**Date of Issue:** August 2022 (*Monogram Program Effective Date: February 2023*)

**Affected Publication:** API Specification 6A, *Specification for Wellhead and Tree Equipment*, 21<sup>st</sup> Edition, November 2018

### Addendum 3

**Table D.9—Type R Ring Gaskets**

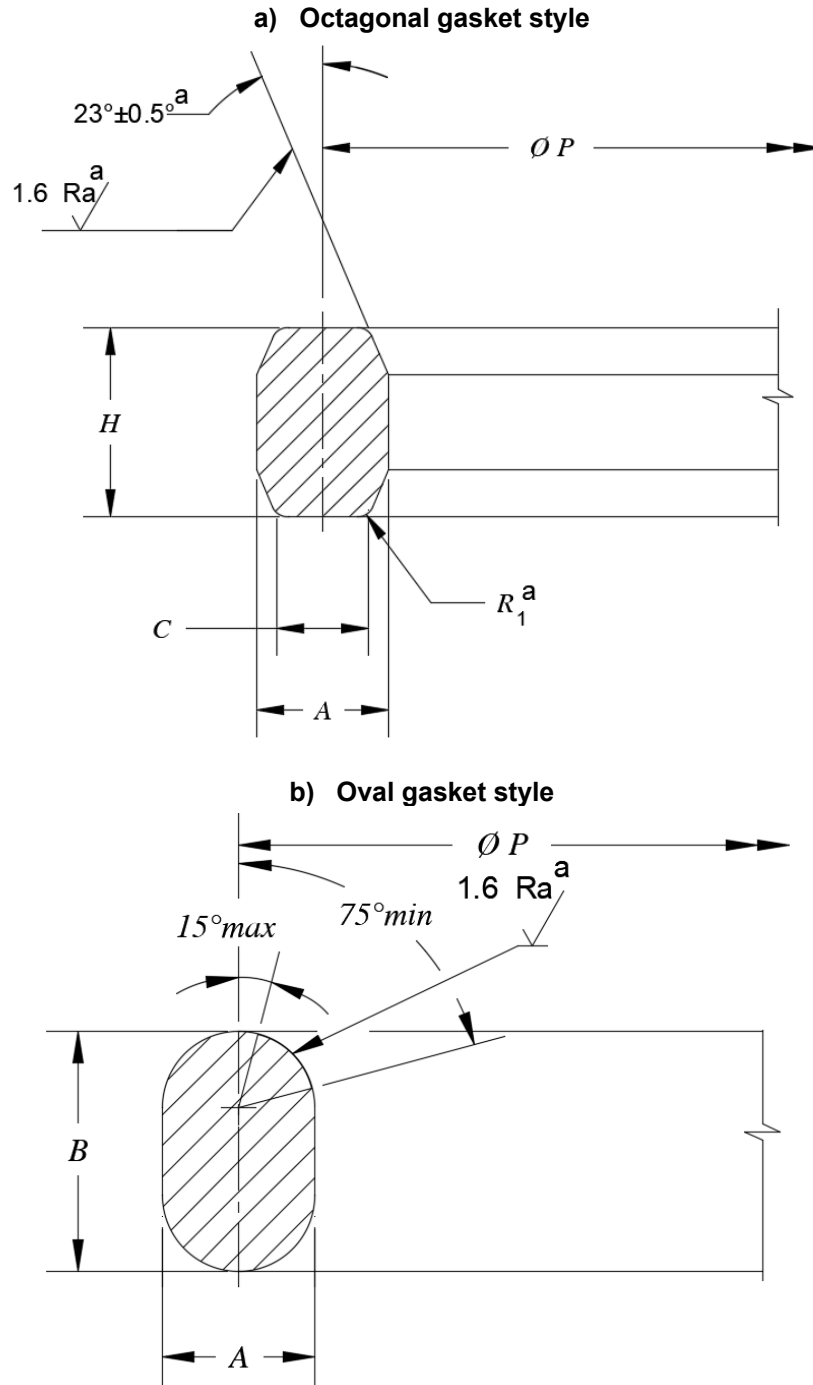
Table D.9: The table shall be changed to the following:

Dimensions in millimeters unless noted otherwise; surface roughness in micrometers

<sup>a</sup> Typical four places.

**Table D.12—Type BX Ring Gaskets**

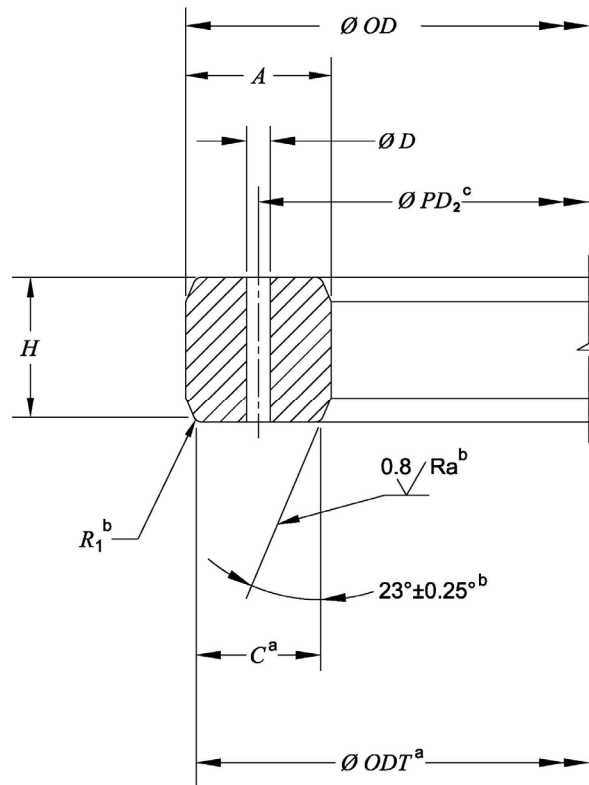
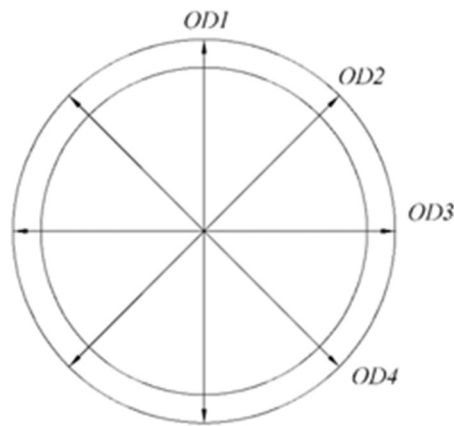
Table D.12: The table shall be changed to the following:

- <sup>a</sup> Typical two places (top and bottom).
- <sup>b</sup> Typical four places (all corners).
- <sup>c</sup> Reference dimension (see Table D.11 for value).

OD MINIMUM INSPECTION LOCATIONS

<sup>a</sup> The requirements of 10.4.5.4.2.3 and 10.4.5.4.2.4 shall apply.

**Table E.9—Type R Ring Gaskets**

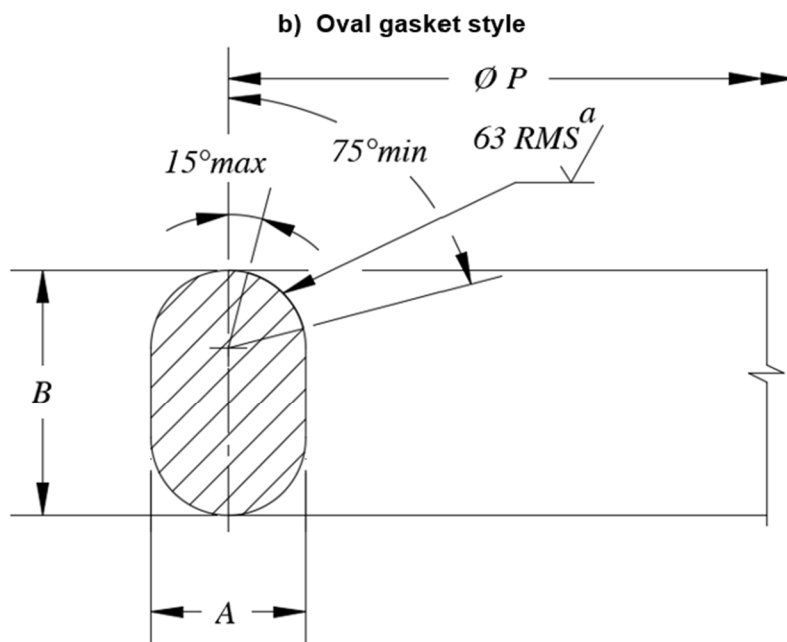
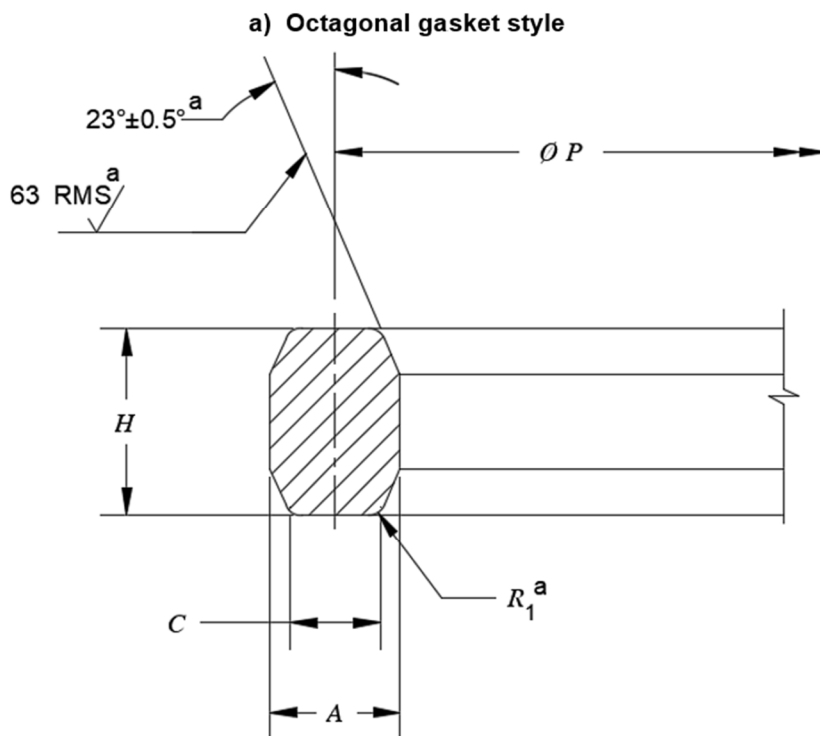
Table E.9: The table shall be changed to the following:

Dimensions in inches; surface roughness in microinches

<sup>a</sup> Typical four places.

**Table E.12—Type BX Ring Gaskets**

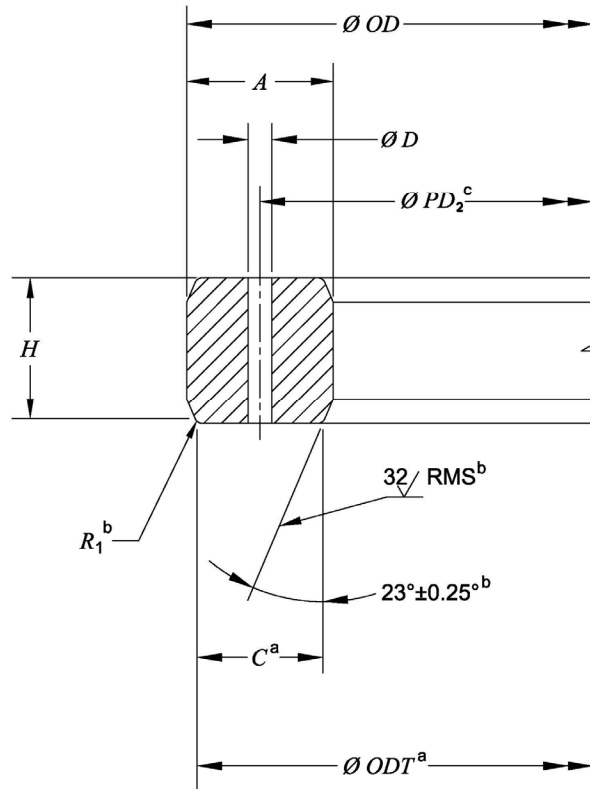
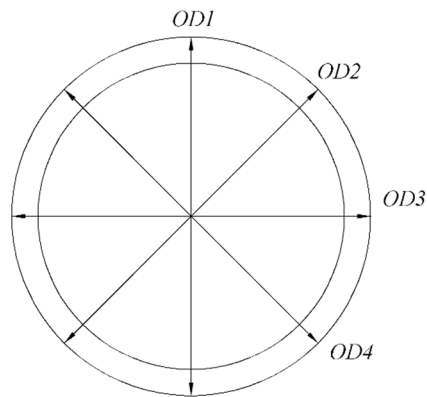
Table E.12: The table shall be changed to the following:

- a Typical two places (top and bottom).
- b Typical four places (all corners).
- c Reference dimension (see Table E.11 for value).

*OD MINIMUM INSPECTION LOCATIONS*

<sup>a</sup> The requirements of 10.4.5.4.2.3 and 10.4.5.4.2.4 shall apply.
